My name is Kevin Gemme, I am in charge of Sales at **Sunrise Tradex Corporation (Gree Canada)**. We have been in the importation and distribution of residential and light commercial heat pump products for almost 20 years in Canada. Our company works with various brands, including Gree, ForestAir, Ecoer, ect...

I was informed by Caroline Côté about the Energy Star® Central Air Conditioners & Air-Source Heat Pumps review that is currently ongoing and she took some time with me to discuss the process and the deadlines involved. With that in mind, I am sharing with you our comments with regards to the 1st draft of the review which werw presented on May 10th 2019.

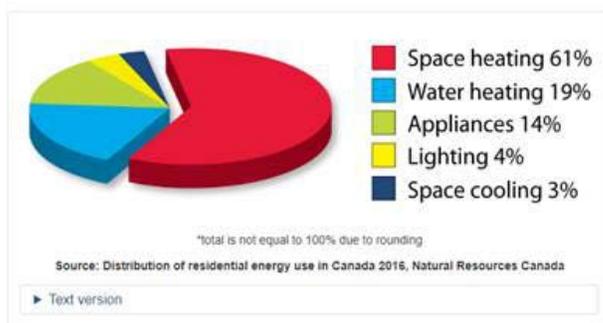
Canada's cold climate means that space heating accounts for a **remarkable 61% of the energy used in the average Canadian home**. No wonder you should look to heating to find energy savings opportunities!

As you can see clearly through this chart, **homeowners living in Cold Climate zones such as Canada spend the big majority of their energy use is for space heating (61%), and very little of their energy in space cooling (3%).**

Considering the changes suggested in this initial draft, we do believe this information is known on your end. With that said however, our opinion is that **the requirements for Energy Star should be even more demanding on heating efficiencies, and less demanding on cooling efficiencies.**
